STAFF REPORT AMENDED 3-22-84
CITY PLANNING COMMISSION

- APPLICATION:
1. Environmental Determination
 2. Special Permit to construct a restaurant in the Flood (F) zone (Sec. 23-C-2-H)
 3. Special Permit to locate parking in the Single Family (R-1) zone (Sec. 2-C-28)

LOCATION: 5888 Riverside Boulevard

PROPOSAL: The applicant is requesting the necessary entitlements to construct a 180-seat restaurant and accompanying parking along the Sacramento River Parkway in the Flood (F) and Single Family (R-1) zones.

SITE DEVELOPMENT PLAN

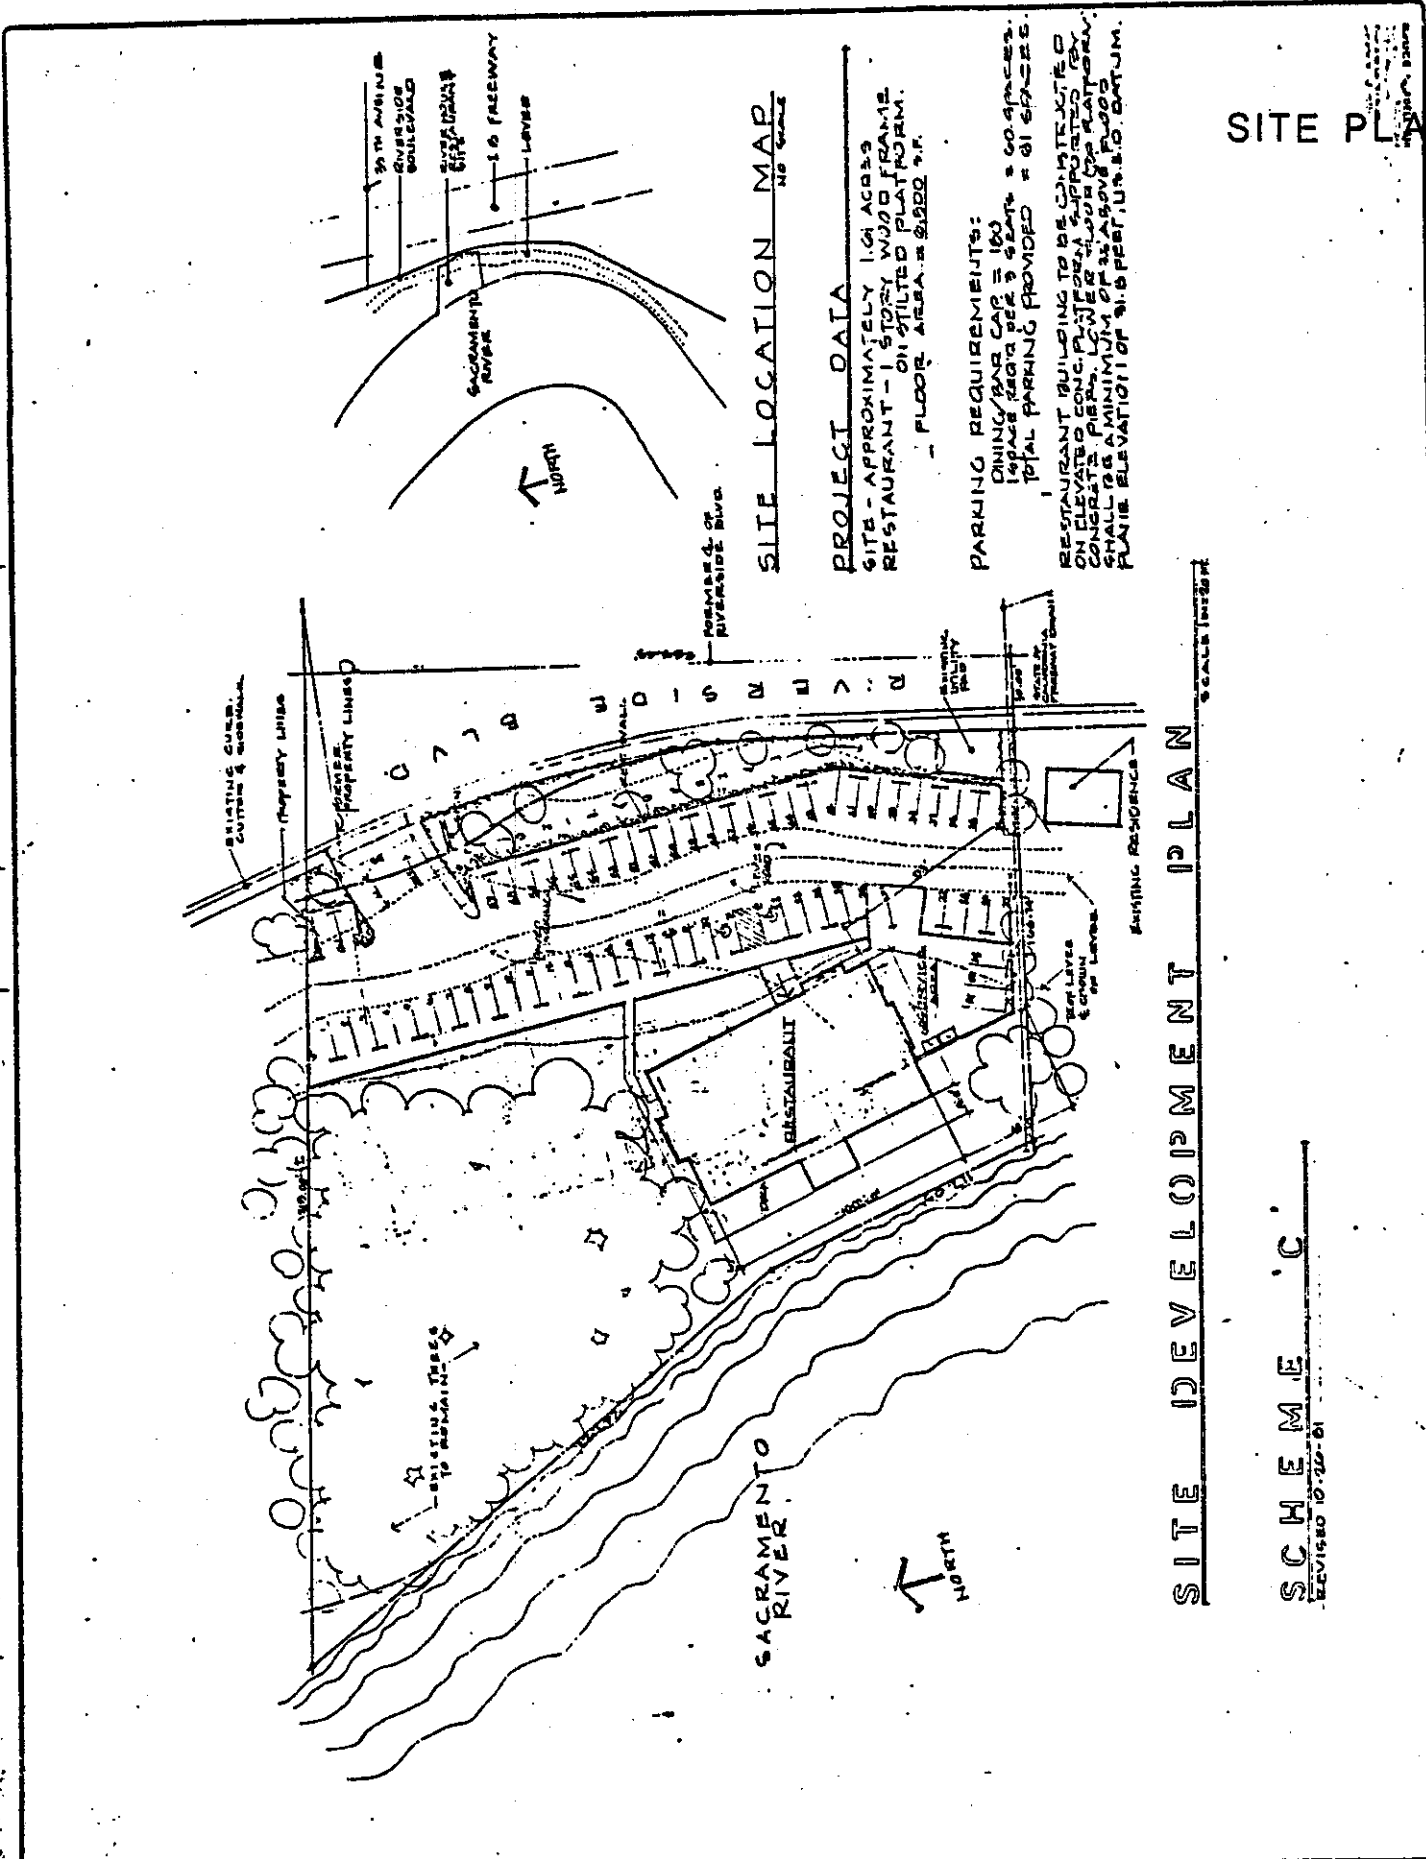
1. The applicant proposes to construct a 6,500± square foot restaurant and cocktail lounge with a seating capacity of 180. Parking standards require 60 spaces at the ratio of one space per three seats. The applicant proposes 61 spaces. The proposed restaurant is to be river-oriented. The applicant is, therefore, proposing to construct the facility on the river side of the levee. The western side of the restaurant will be constructed on concrete piers of up to 14 feet in height. Compacted fill up to 11 feet in height placed along the river side of the levee will support the rear portion, eastern side of the structure. This will place the structure at 35 feet which is above the 100 year floodplain elevation of 31.8 feet.

Fifty-eight of the parking spaces are to be located along the levee road, with backout maneuvering space onto the road. Land fill up to 14 feet in height will be placed on both sides of the levee, the length of the subject site, to create a flat parking area. A 14-foot high concrete retaining wall will be constructed on the landward side of the levee along Riverside Boulevard. No wall is proposed along the river side of the levee. Three additional parking spaces are located in the service area next to the restaurant.

2. There are a substantial number of trees on the subject site. These consist of Willows, Cottonwoods, Alnus and two Oaks, 18 inches and 24 inches in diameter. These trees are located primarily north of the actual restaurant site. Fifteen trees are proposed for removal from the southeast corner of the woodland area. None of the trees are Oaks. This will leave the major portion of the climax riparian vegetation intact for wildlife habitat.

- a. The applicant shall submit parking lot drainage plans for review and approval of the City Engineer;
- b. The applicant shall submit a detailed survey of all existing vegetation on the site which shall indicate trees and major shrubs to be 1) retained; 2) trimmed or modified, or 3) removed. This survey shall be subject to review and approval by the City Planning Director, Community Services Department and the Corps of Engineers;

- d. An exterior lighting plans shall be subject to review and approval by the City Electrical Engineer and the Planning Director;
- e. No building permit or other entitlement shall be issued unless certification is provided to the Director of Building Inspections from a registered professional engineer that said development will not increase the level of the base flood;

RIVERHOUSE RESTAURANT
 BUILDING SIGN PLAN SHT. NO. 2
 DATED 2-9-81
 REVISED 10-21-81

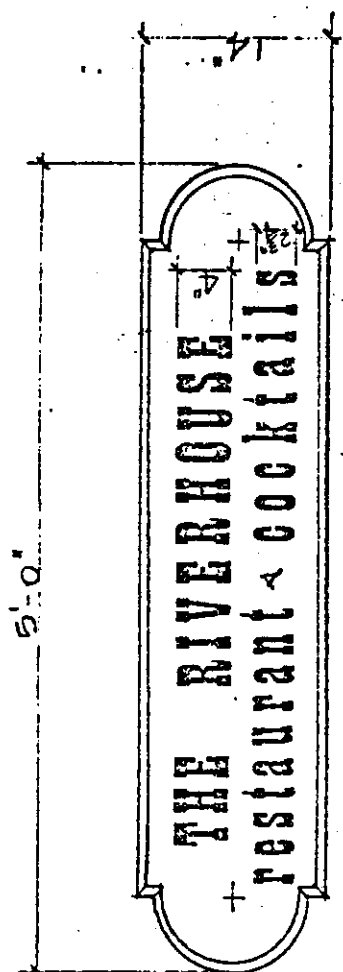
5. A sign is indicated on the roof facing both the river and the freeway. This is a violation of the Sign Ordinance (Sec. 3.156) unless a special permit is obtained. Other signage on the site was reviewed by the Design Review Board. Graphics and design were found to meet Design Review Board guidelines. Location and size of signs must comply with sign ordinance regulations.

- l. Signage shall be reviewed by Planning staff for compliance with Sign Ordinance regulations prior to issuance of building permits.

LANDSCAPE PLAN

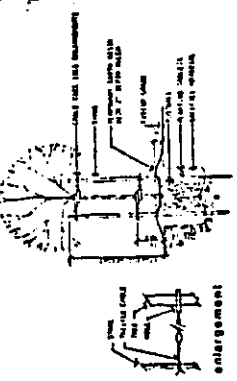
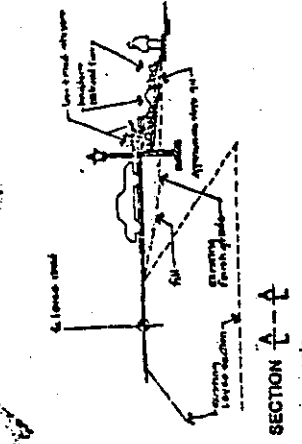
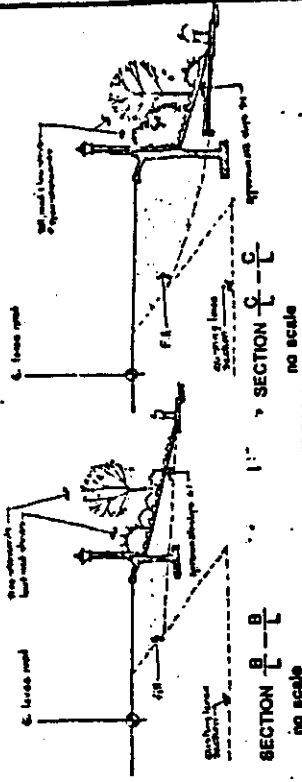
8. The applicant will be required to submit surfaced area landscaping, irrigation and shading plans prior to issuance of building permits. Landscaping guidelines are included in Exhibit A.

- c. The applicant shall submit a detailed landscaping and irrigation plan for the restaurant structure, parking lot and retaining wall area. Plans shall be reviewed and approved by the City Planning Director and Community Services. The landscaping plan shall be consistent with guidelines listed in Exhibit A;
